# Correcting the module stressed input loss calibration

P802.3ck D2.3 comment 32

Piers Dawe, Nvidia

Figure 120G-10—Example module stressed input test

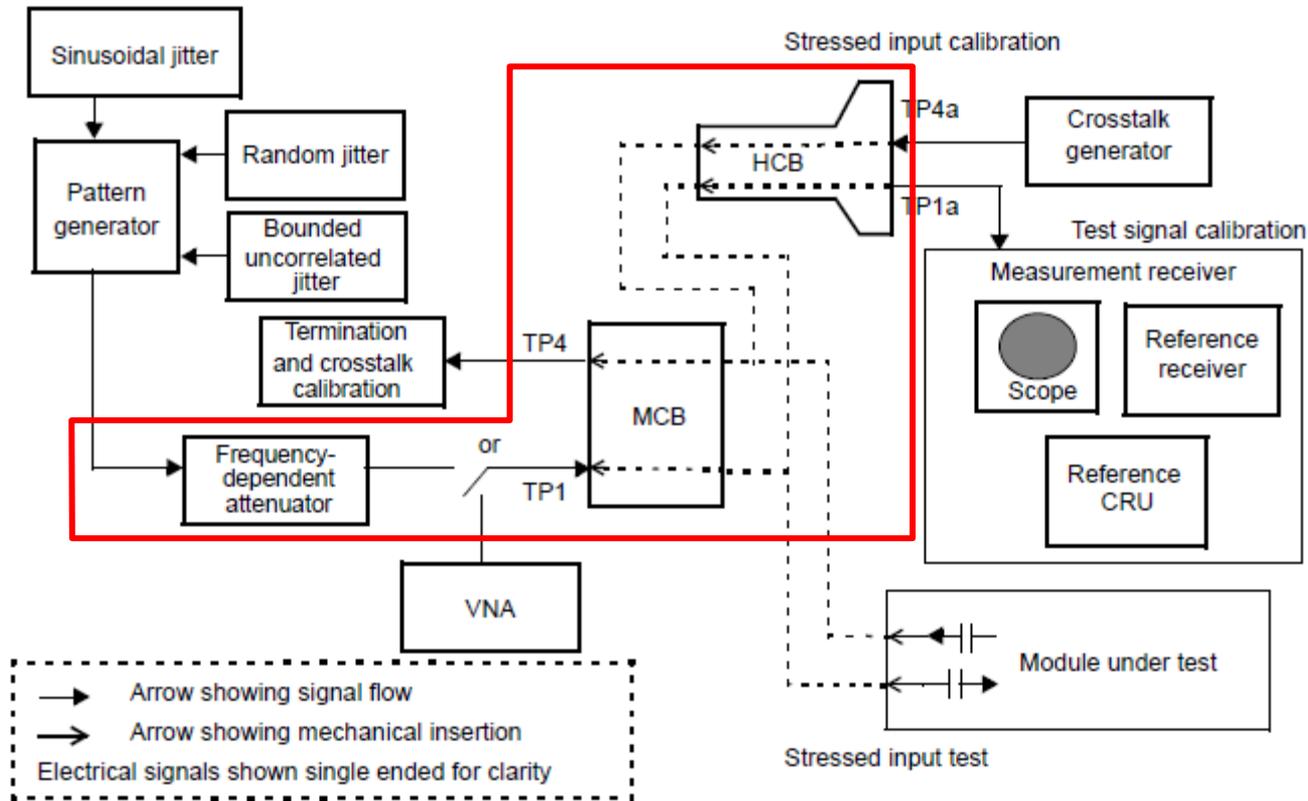
- Loss is calibrated from the output of the pattern generator to TP1a

Figure 120G-11—Module stressed input target high-loss frequency-dependent attenuator differential-mode to differential-mode insertion loss

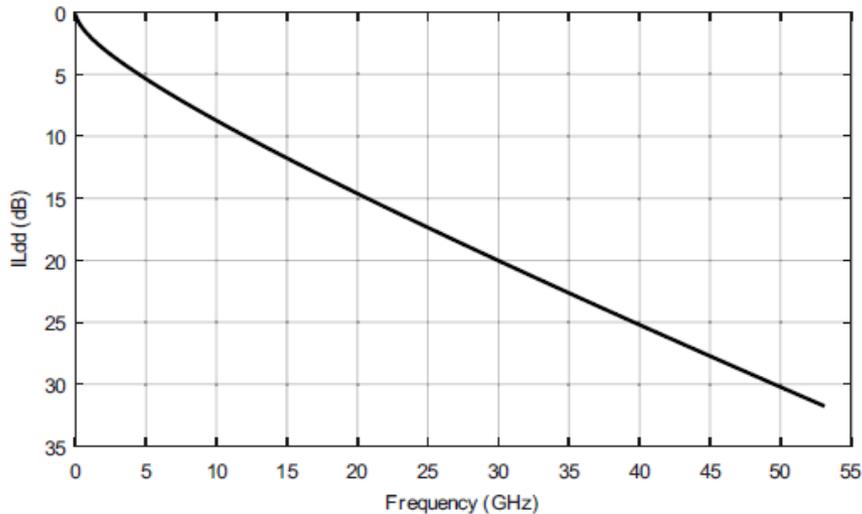
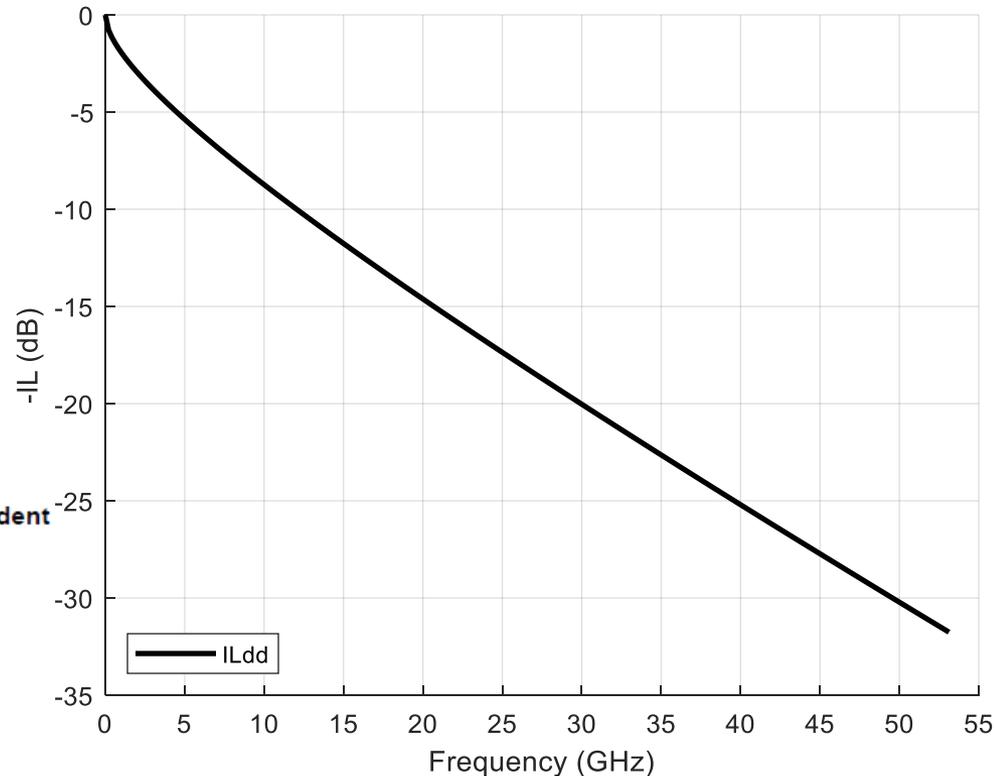
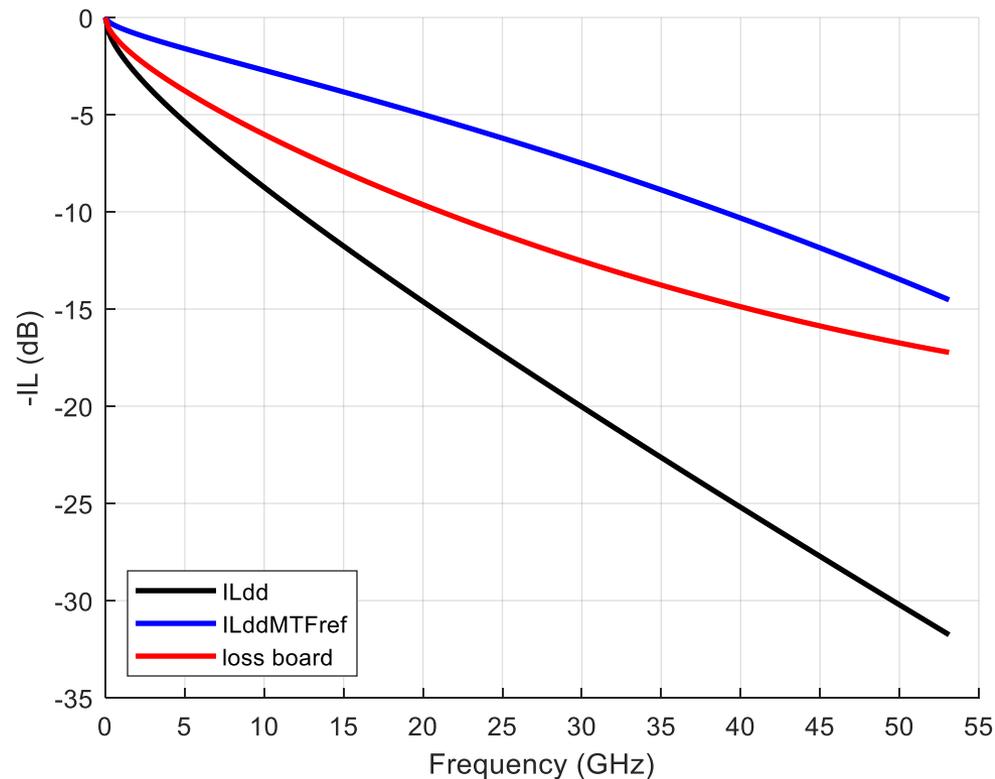
- 18.2 dB at Nyquist
- $IL_{dd}(f) = 1.54\sqrt{f} + 0.3865f$  (120G-3)
- In spite of the figure title, this is not the frequency-dependent attenuator alone

- The mated compliance boards target the blue line
  - $ILddMTFref(f) = 0.942(0.471vf + 0.1194*f + 0.002*f^2)$  Eq 162B–5
  - 6.6036 dB at Nyquist
- So the frequency-dependent attenuator must target the red line which bends too much the wrong way ( $f^2$  term with wrong sign)
- Impractical, and not representative of the host-to-module channel and the channels used for module output compliance

- Change L from 464 to 296 mm;
- Revise text and equation 120G-3
- Eq 120G-3 becomes  $0.981\sqrt{f} + 0.2462f$  for the frequency-dependent attenuator;
- Show all three curves (Eq 162B-5 mated compliance boards, frequency-dependent attenuator and the combination) in Figure 120G-11. Revise its title
- The loss of the combination is  $1.425\sqrt{f} + 0.3588f + 0.001884f^2$

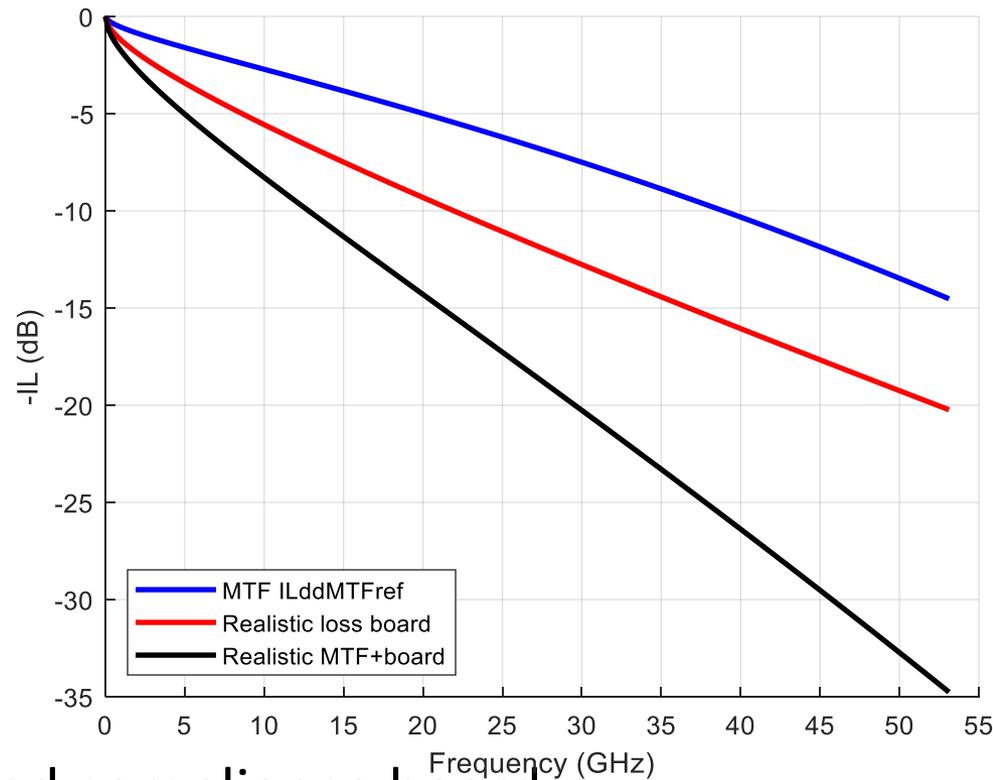
- Instead, choose the transmission line length so that the sum of the mated compliance boards and the frequency-dependent attenuator is the target 18.2 dB
- Frequency-dependent attenuator loss target for ideal compliance boards is 11.5964 dB
  - 295.590 mm

- **Blue: mated compliance boards**
  - $IL_{ddMTFref}(f) = 0.942(0.471vf + 0.1194*f + 0.002*f^2)$  Eq 162B–5
  - 6.6036 dB at Nyquist
- **Red: frequency-dependent attenuator**
  - $0.980926vf + 0.246243f$  (Eq 120G-3 revised) 11.5964 dB at Nyquist
- **Black: total**
  - $1.42461vf + 0.358718*f + 0.001884*f^2$  18.2 dB at Nyquist
- **Practical and representative of the host-to-module channel**
